Groundwater Application Review Summary Form

Application # G- 19412

PUBLIC INTEREST REVIEW FOR GROUNDWATER APPLICATIONS

A. GENERAL INFORMATION: Applicant's Name: Butter Creek Cattle c/o Steve Currin County: Morrow

Water-Level Measurements in Nearby Wells

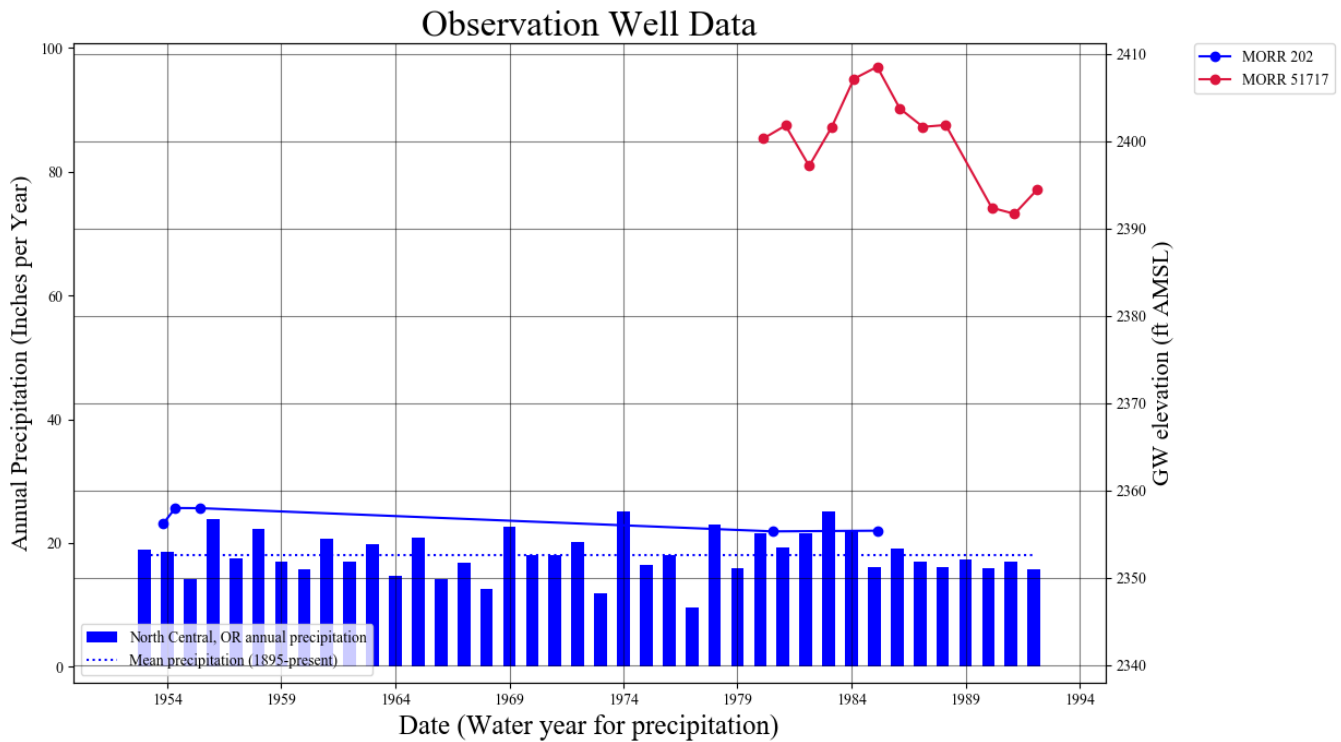
Basalt wells with water level data are scarce in the area of the POAs. The nearest wells with water level data are MORR 202 and MORR 51717, completed approximately ½-mile and 1-mile southeast of POA 1, respectively. These wells are relatively shallow compared to the proposed depths of the POAs (150-210 feet bgs vs. 400 feet bgs). These wells only include water level data until 1993, which indicate a relatively stable trend. Significantly deeper (300+ feet completion) wells with water level data completed in the Grande Ronde are approximately 7 miles north of the POAs, completed near Butter Creek. Wells completed in the same aquifer system ~5+ miles to the west-northwest, to the southwest, and to the east show similar declining trends. Basalt wells to the north completed near Butter Creek show consistently declining water levels since the 1950s. Based on limited well location and water level data, it cannot be determined that groundwater is over appropriated at the proposed POAs. **In order to determine if groundwater is over appropriated within the vicinity of the POAs, modern day measurements at MORR 202 and MORR 51717 must be taken during the month of March.**

Theis Interference Analysis

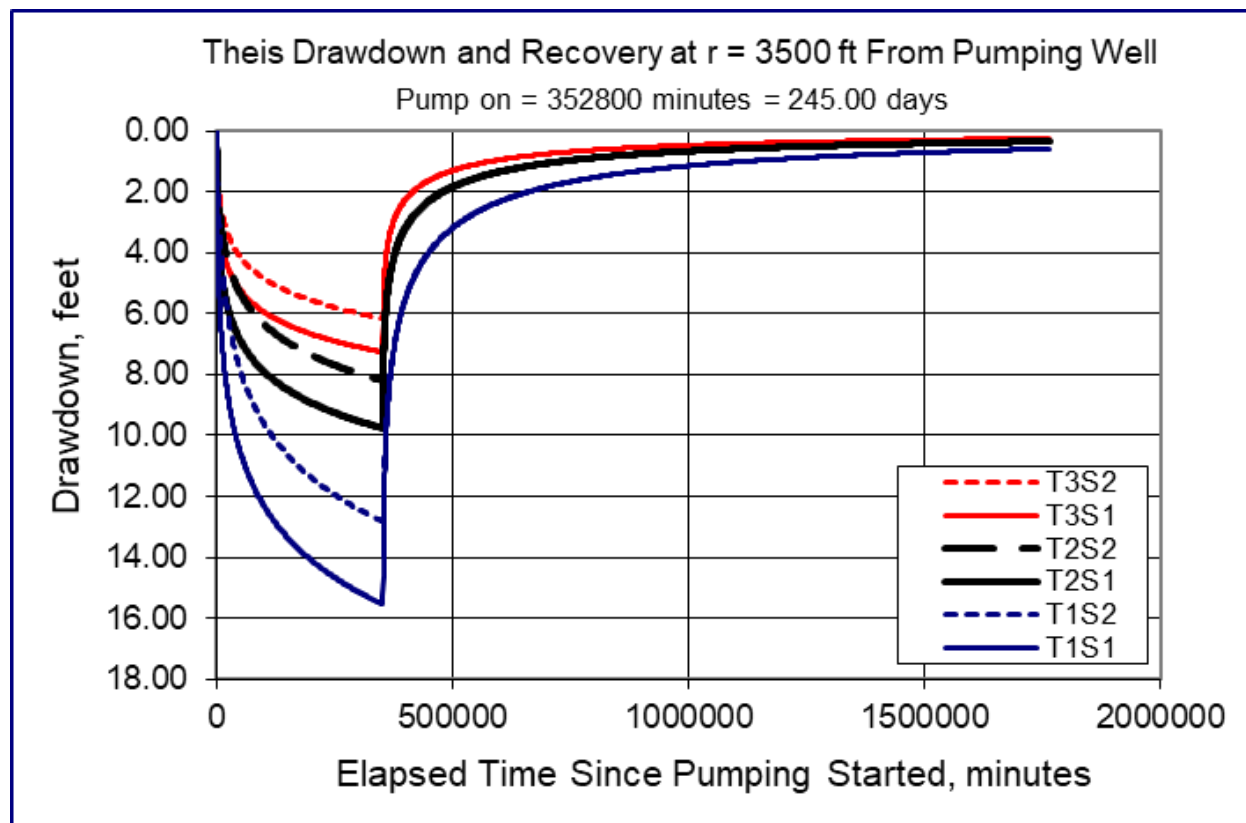
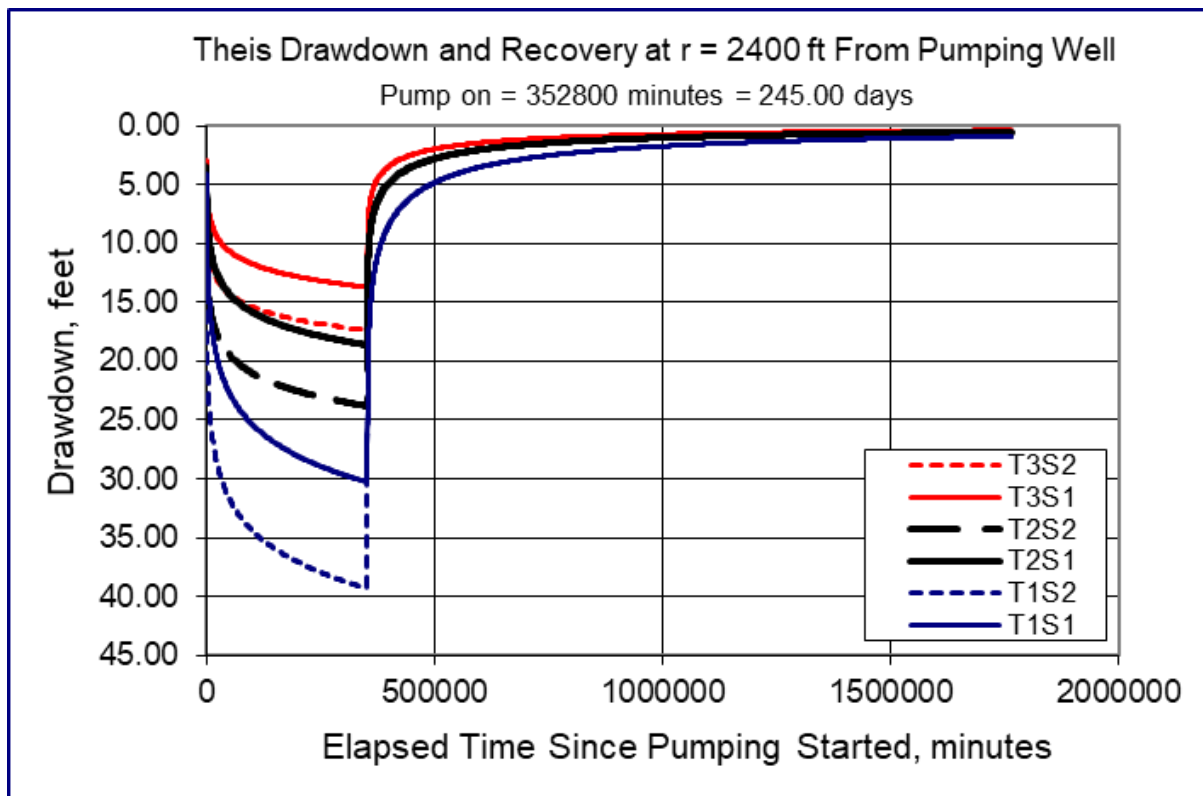
Hydraulic Conductivity: Values ranged from 2 ft/day (MORR 317 well test) to 36 ft/day (MORR 61 well test) over five well tests complete in the Grande Ronde Formation of the Columbia River Basalt Group (MORR 60, MORR 61, MORR 317, MORR 51098, MORR 51210). The final transmissivity estimates of 2,348, 4,090, and 5,796 were the 1st, 2nd, and 3rd quartiles from 200-model runs using a range of the previously stated hydraulic conductivity values.

Storativity: 0.0001 to 0.00001 (USDOE, 1988; Porcello et al., 2009). The final storativity estimates of 0.00027 and 0.00077 are the 1st and 3rd quartiles from 200-model runs using this range of storativity values.

Time: 245 days (Irrigation Season).

Rate: (1) 0.89 cfs (POA 1 Rate); (2) 1.34 cfs (POA 2 Rate); (3) 0.22 cfs (POA 3 rate); (4) 0.5 cfs (POA 2 suggested rate)

POA 2 Rate and Distance

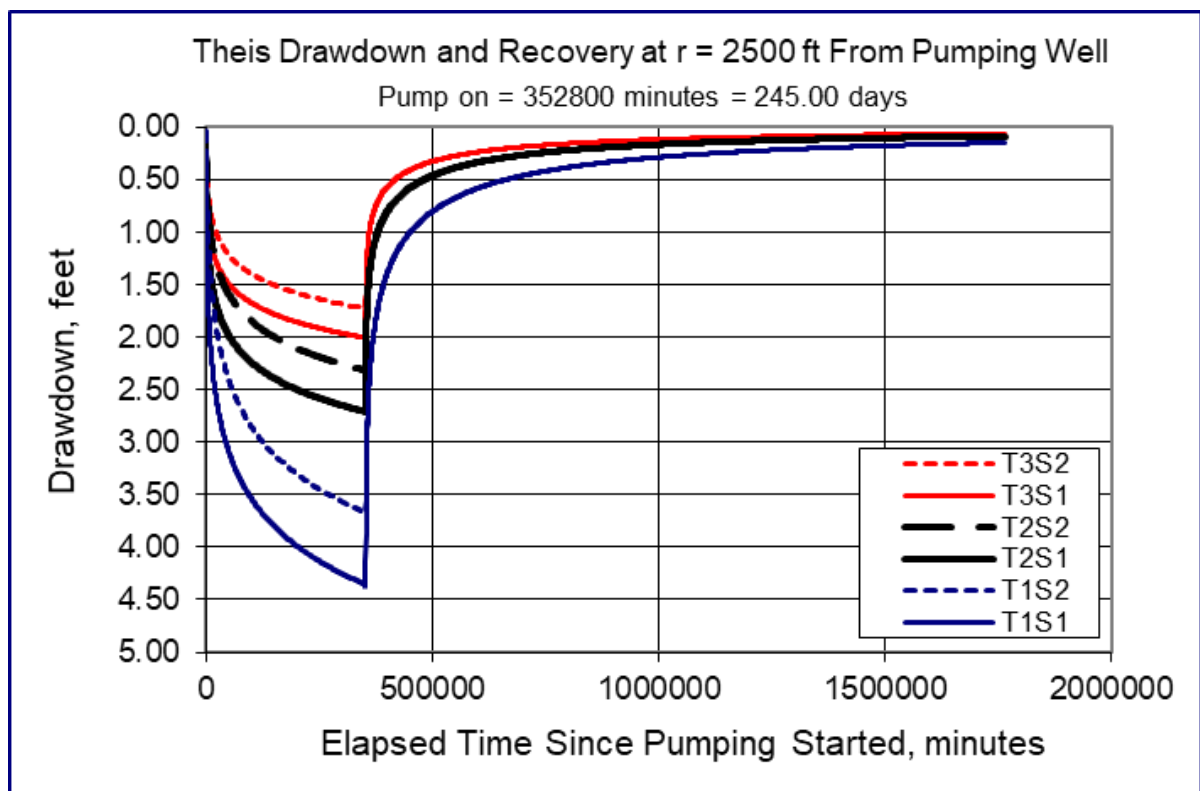
Given a rate of 600 gpm for POA 2, drawdown at the nearest well is estimated between 13 and 38 feet of drawdown over a 245-day (irrigation) pumping period. The nearest known well with location data (MORR 51162) completed in the same aquifer as proposed POA 2 is at least 2,400 feet northwest of the well location. This amount of drawdown is likely to cause interference but will not constitute injury to MORR 51162, which is a domestic well. POA 2 could also potentially interfere with MORR 92, another domestic well, though its location data are less certain. The nearest well (MORR 202) to POAs 1 and 3 is 3,500 and 2,500 feet southeast of the POAs, respectively, and combined drawdown at MORR 202 from pumping both POA 1 and 3 is estimated between 7 and 20 feet. Breakdowns of each parameter are described in the **Theis Interference Analysis** section of the appendix. **Because the requested rate is within the range of well yields in the area and will likely not cause injury to nearby wells, POAs 1 through 3 are likely within the capacity of the resource.**
